## *City of El Paso – City Plan Commission Staff Report*

**Case No:** SUSU12-00007 Rio Valley Subdivision  
**Application Type:** Major Combination  
**CPC Hearing Date:** March 8, 2012

# ATTACHMENT 5

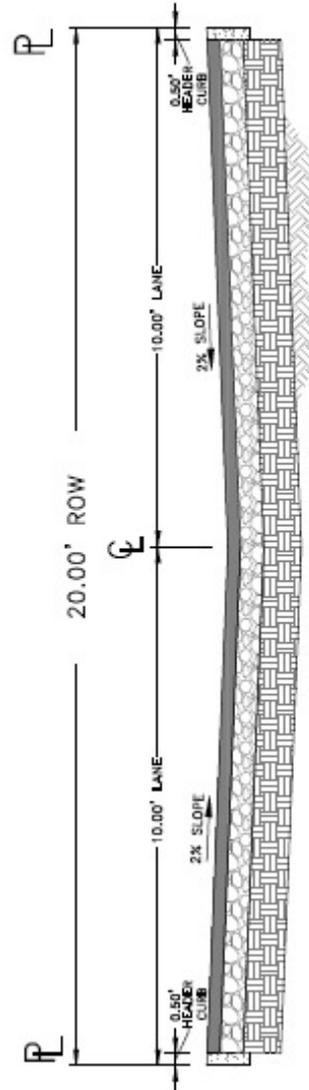
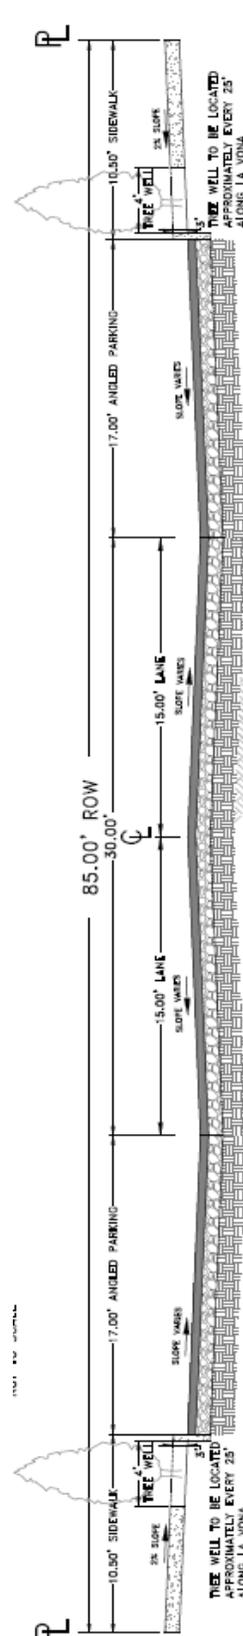
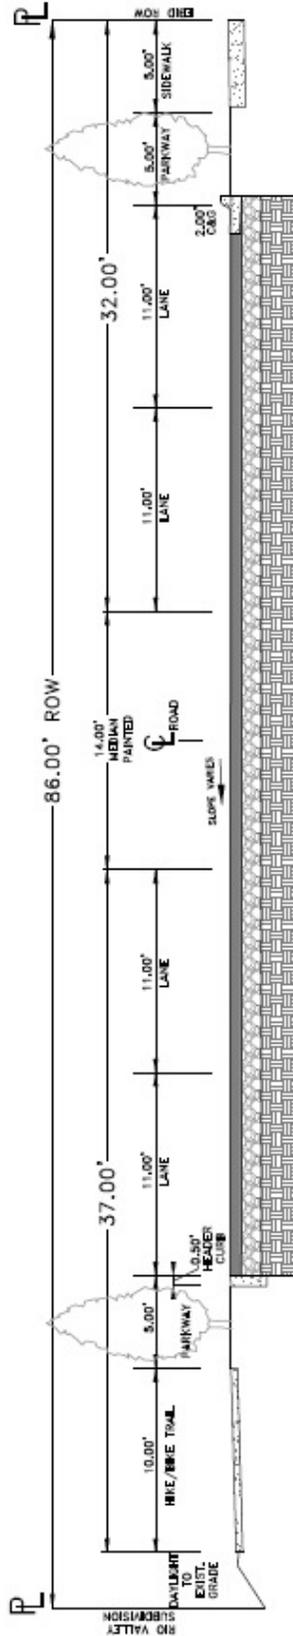
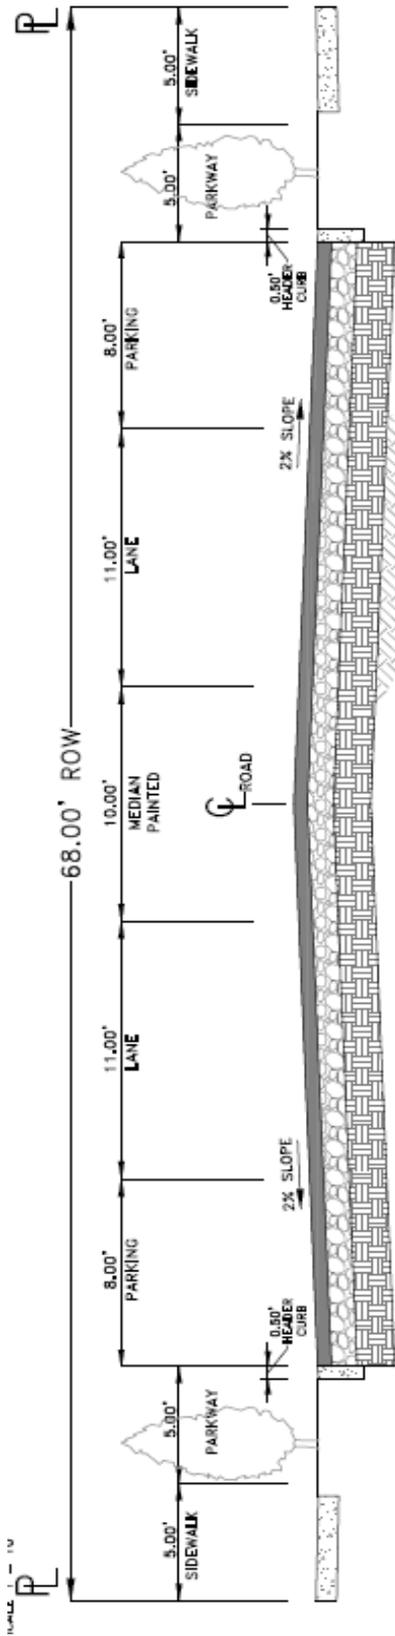
1. To allow for residential lots to abut a park within Blocks, 4, 5, and 8.
2. To allow for 20-ft alleys within Blocks 11, 13, and 14.
3. To allow for alternative roadway cross-sections on Westside Drive and Borderland Road.
  - Westside Drive will consist of an 86-ft right-of-way, to include 58-ft of pavement, a 10-ft hike/bike trail abutting the proposed development and a 5-ft sidewalk on the opposite side, and 5-ft parkways.
  - Borderland Road will consist of a 68-ft right-of-way, to include 48-ft of pavement, 5-ft sidewalks and 5-ft parkways on both sides of the road.
